PLANNING & ZONING COMMISSION
Regular Meeting
Wednesday, January 8, 2020
6:30 p.m.

**A. 2020-02 1297 McCarthy Road Mixed Use Preliminary
Planned Unit Development**

Preliminary PUD Plans

HAMILTON'S PUB - MIXED USE DEVELOPMENT

CONCEPT SITE ENGINEERING PLAN

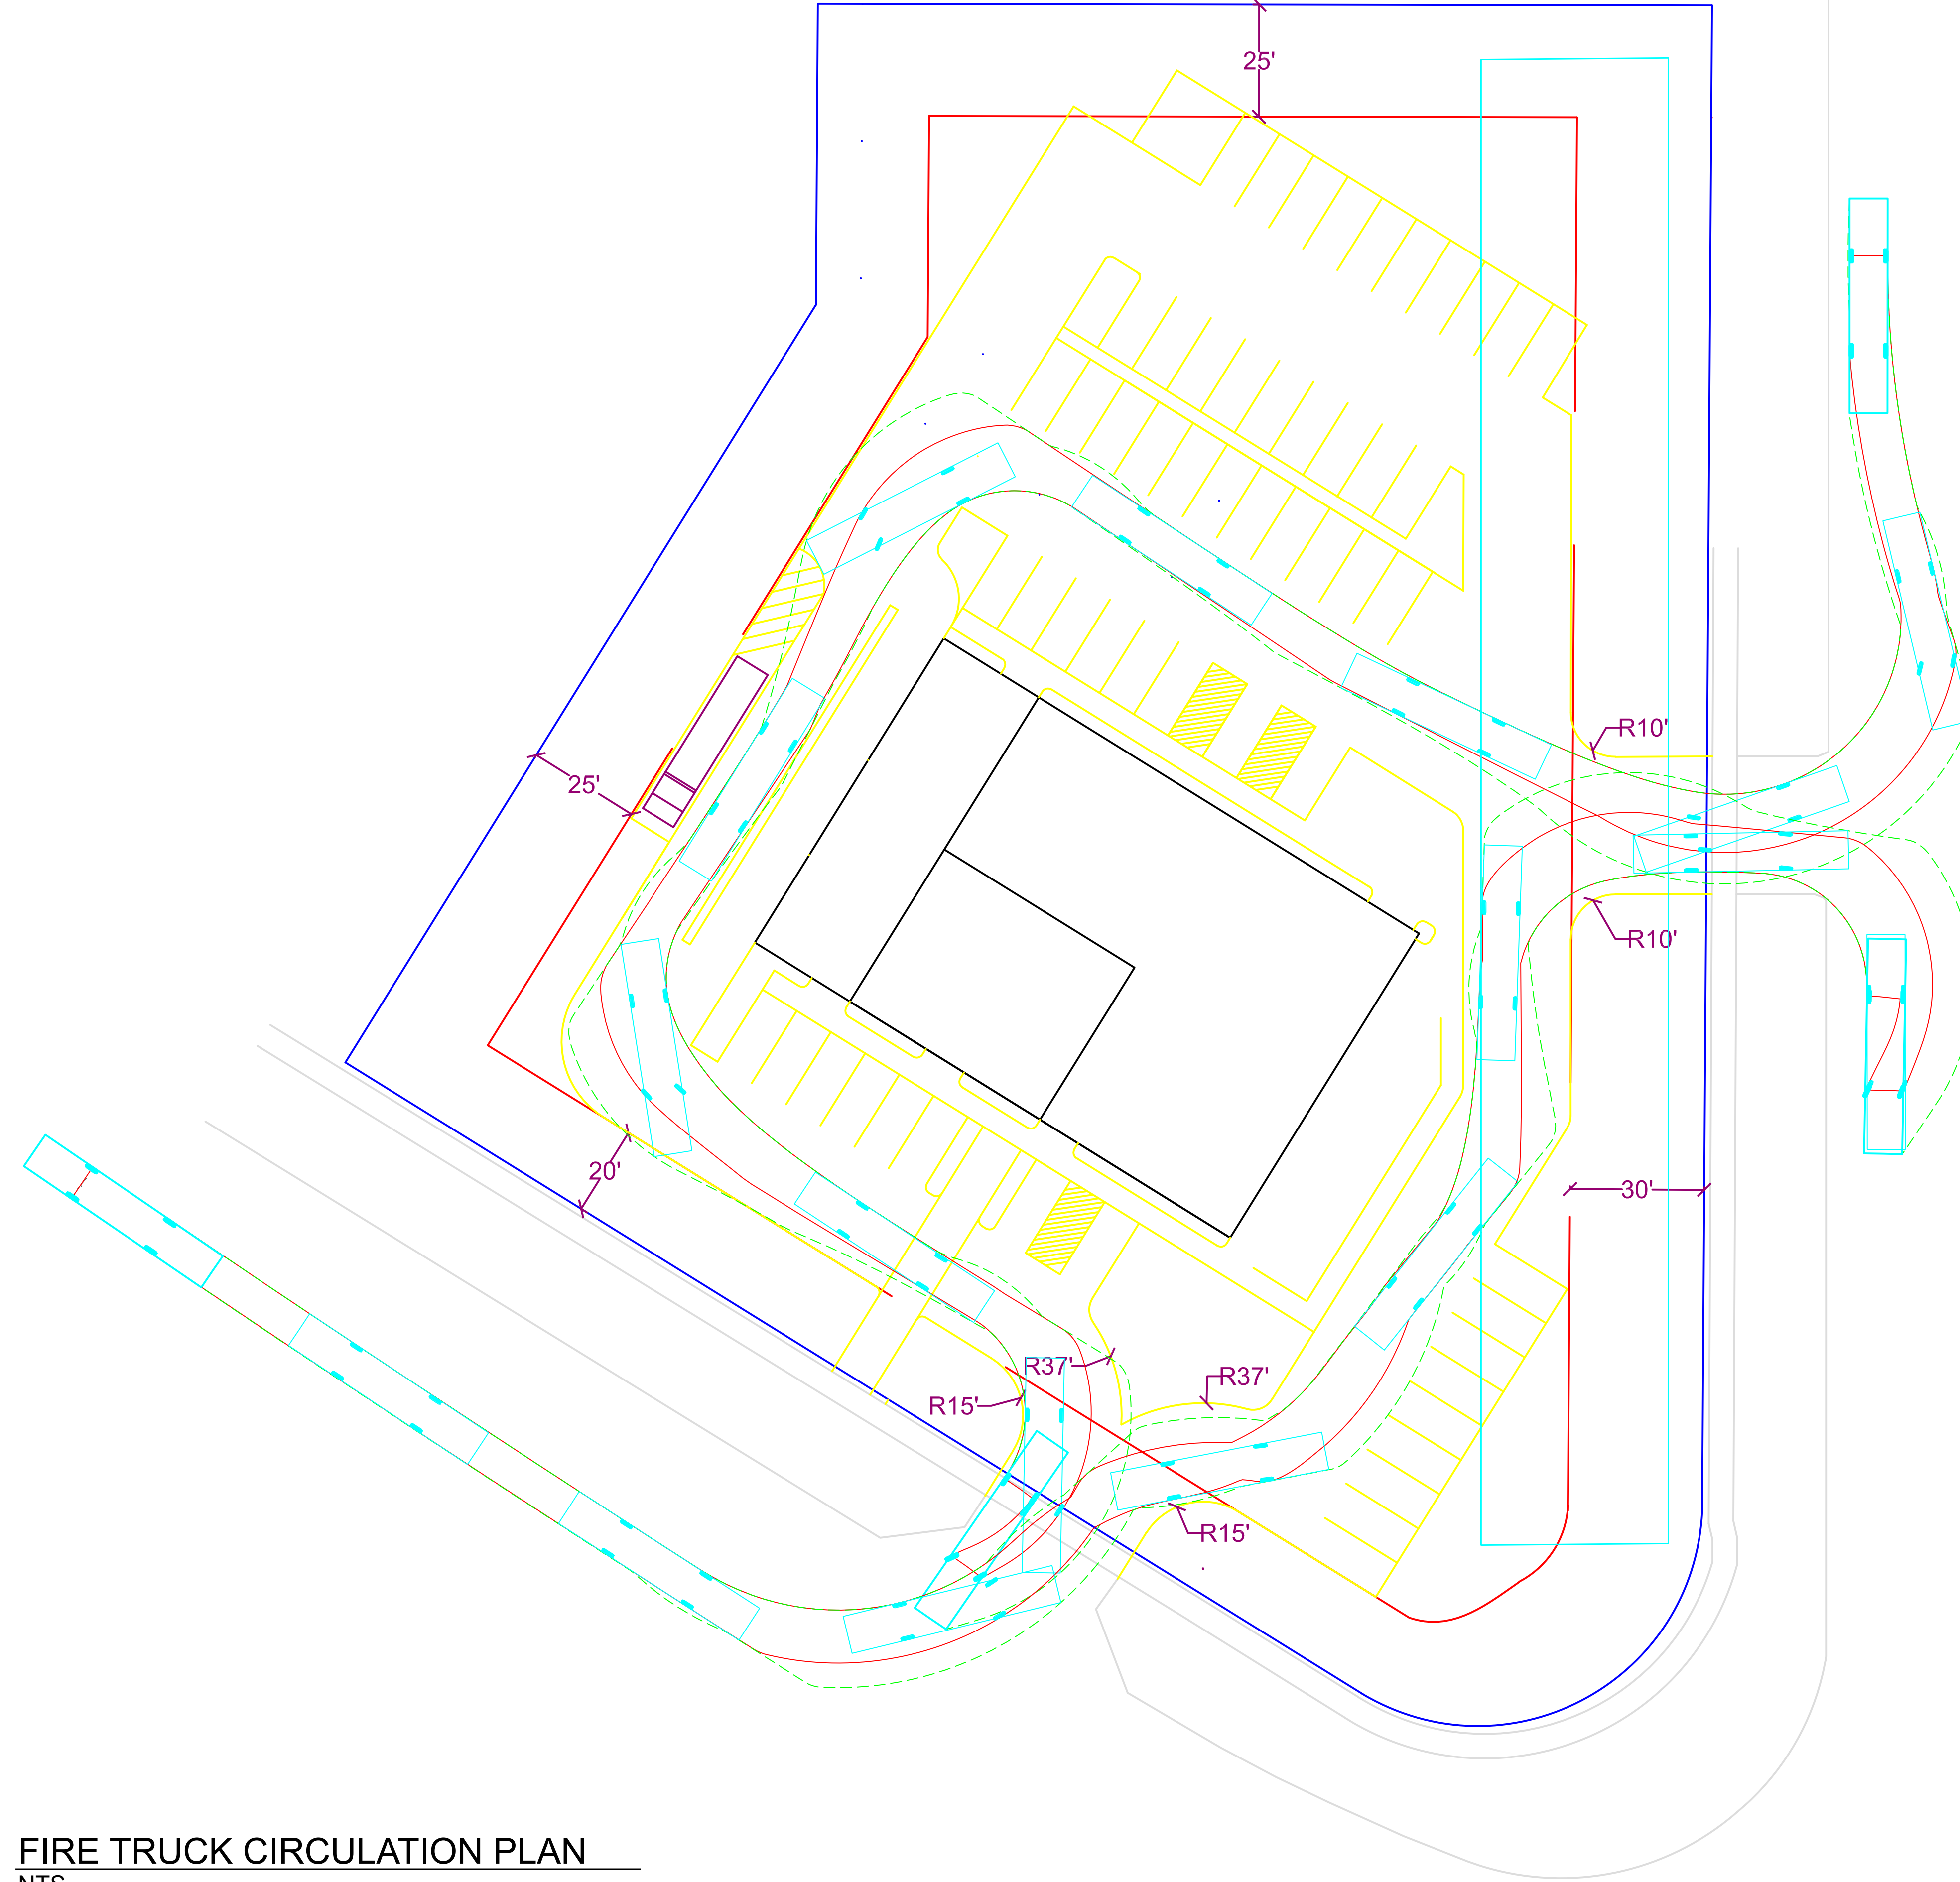
Engineering Comments & Stormwater Management. The Village Engineer is currently reviewing the preliminary plans, but he did provide initial informal comments. He is asking for clarification on how stormwater detention volumes were computed for the proposal, but he did feel that the rates were reasonable if the computations are acceptable. The Village Engineer also stated that the underground detention storage can only be as deep as the available offsite drainage outlet in McCarthy Road, so that value must be verified. He is also asking for contour elevations on the plan as they were not provided, in order to check the side slopes or 'berm rule' for the detention basin. The engineer's full comments will be provided once completed.

TRC Plan and Comments

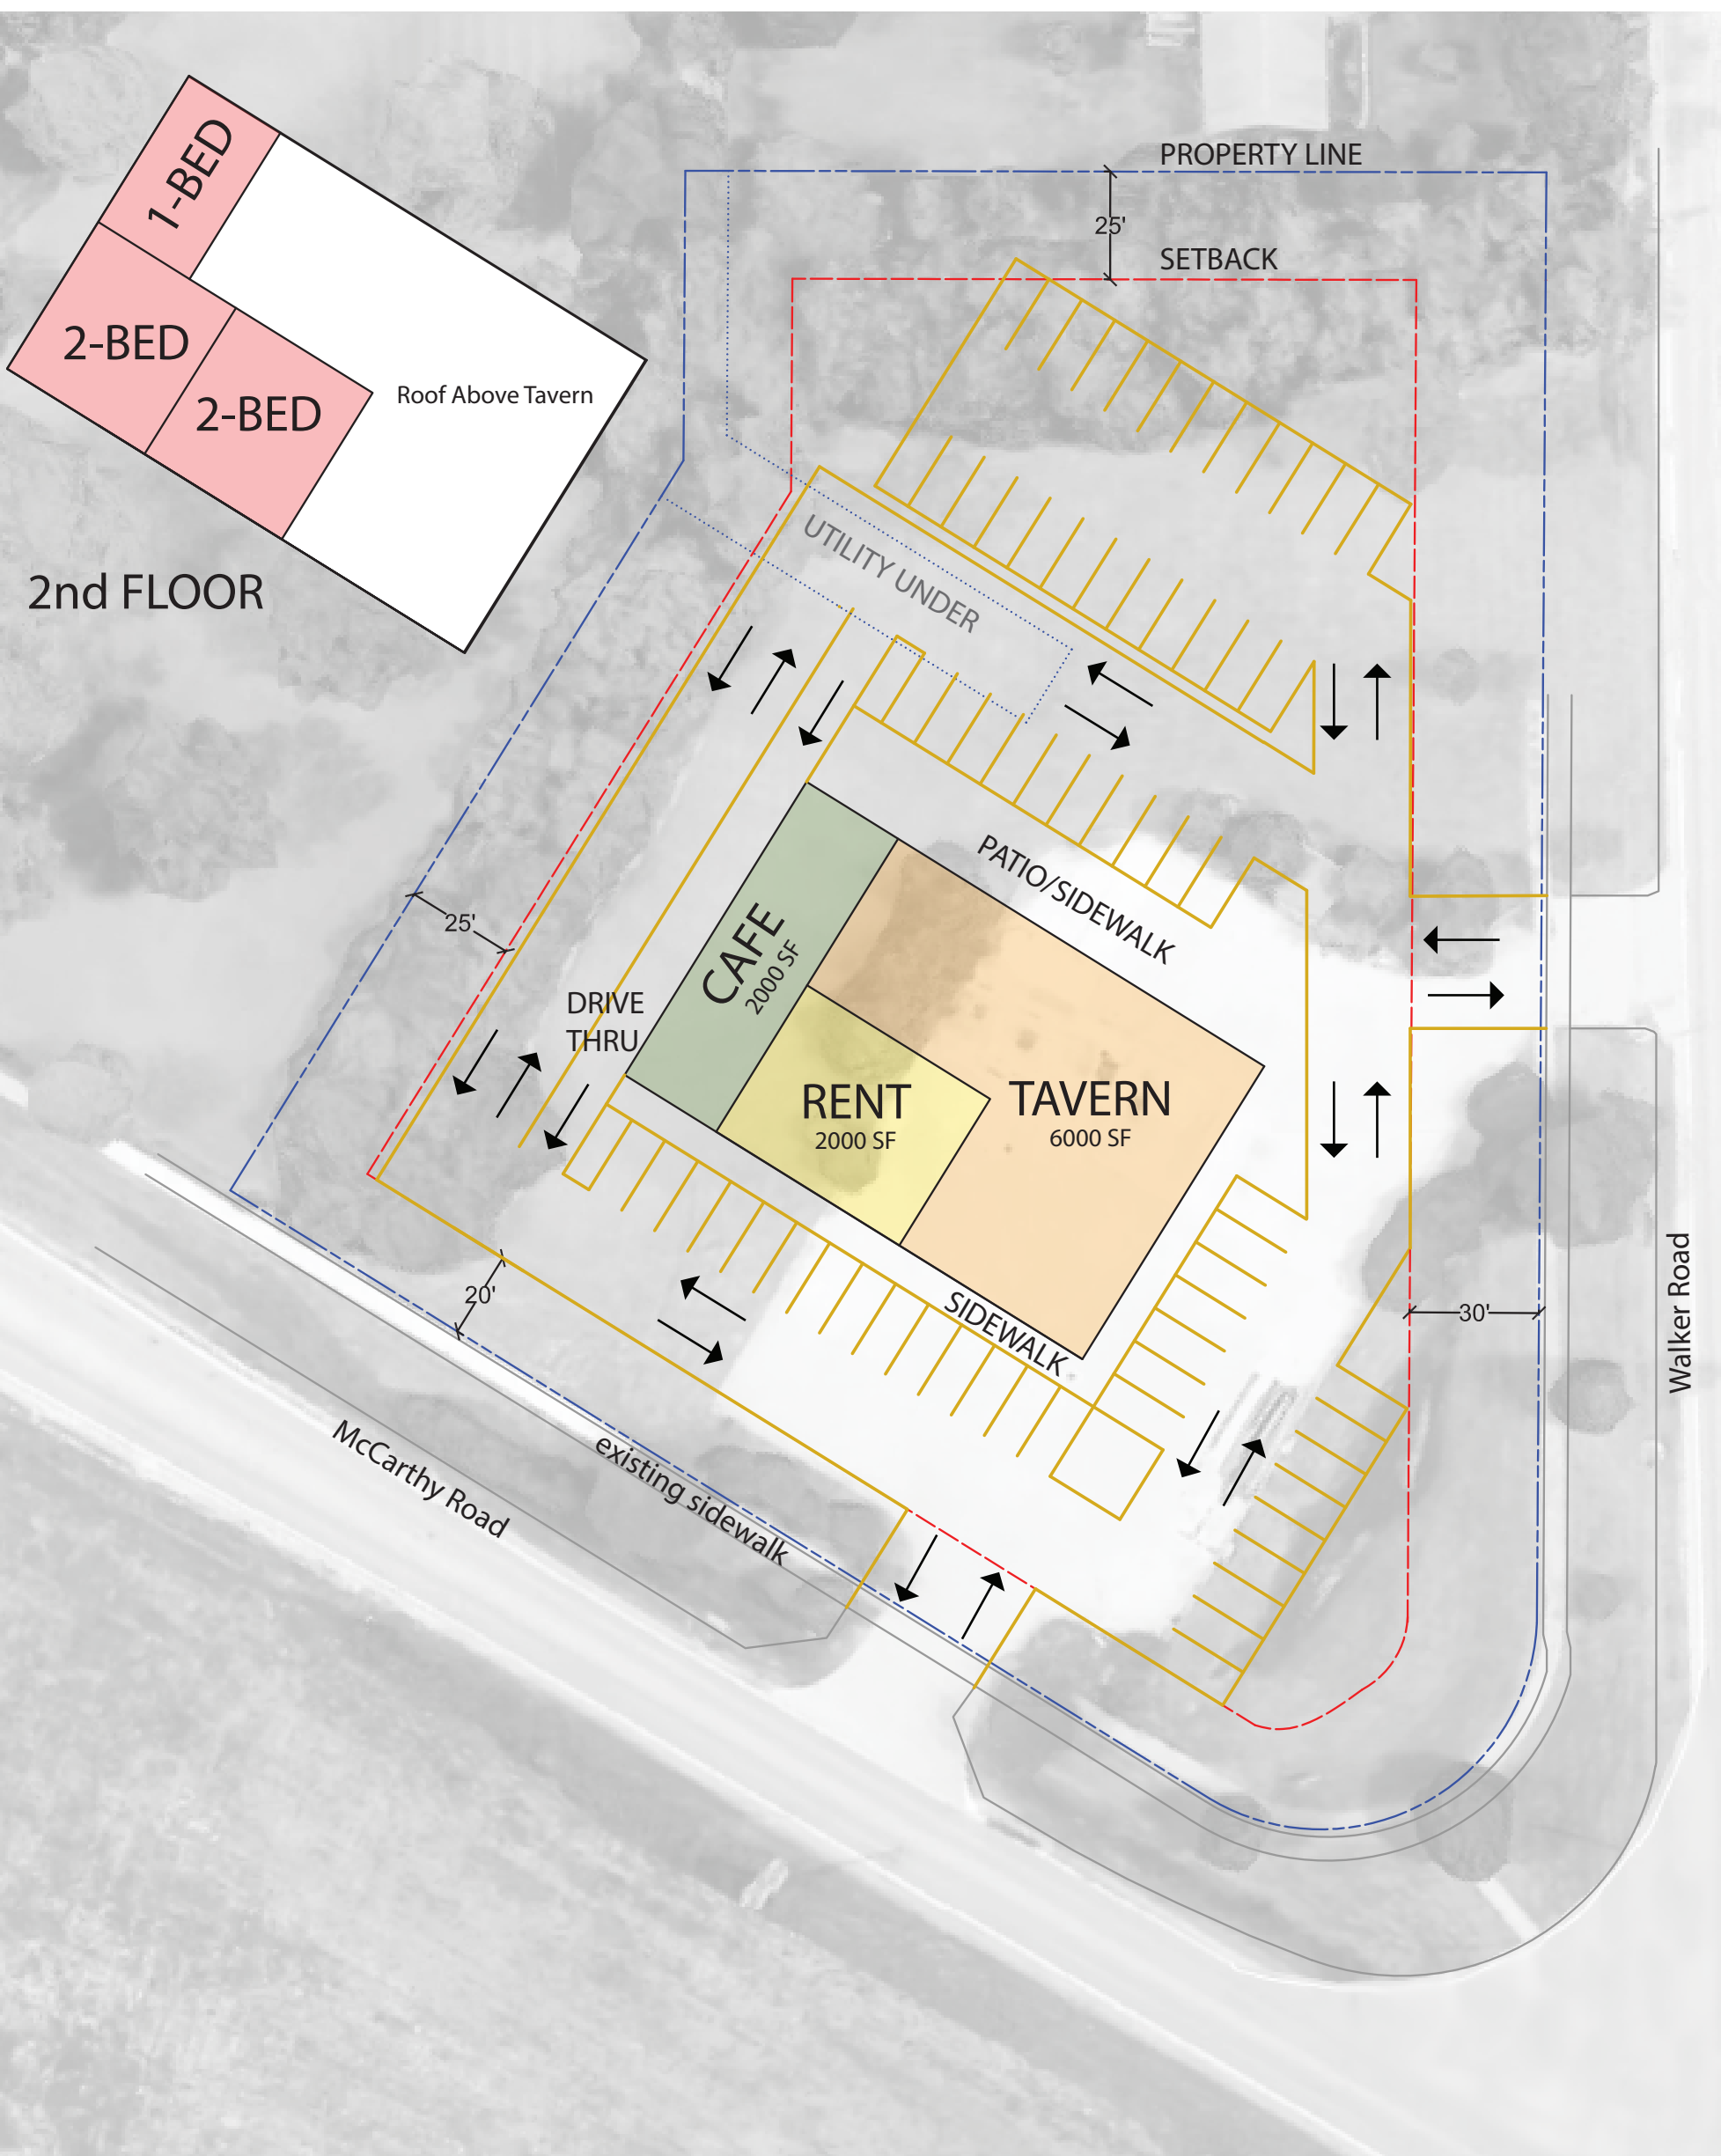
- 5. A dumpster enclosure will be required per §17.06.030 G. Permitted materials are wood or masonry, no chain link.
- 6. Verify a delivery truck can maneuver through the site. What kind of trucks? Time of day?
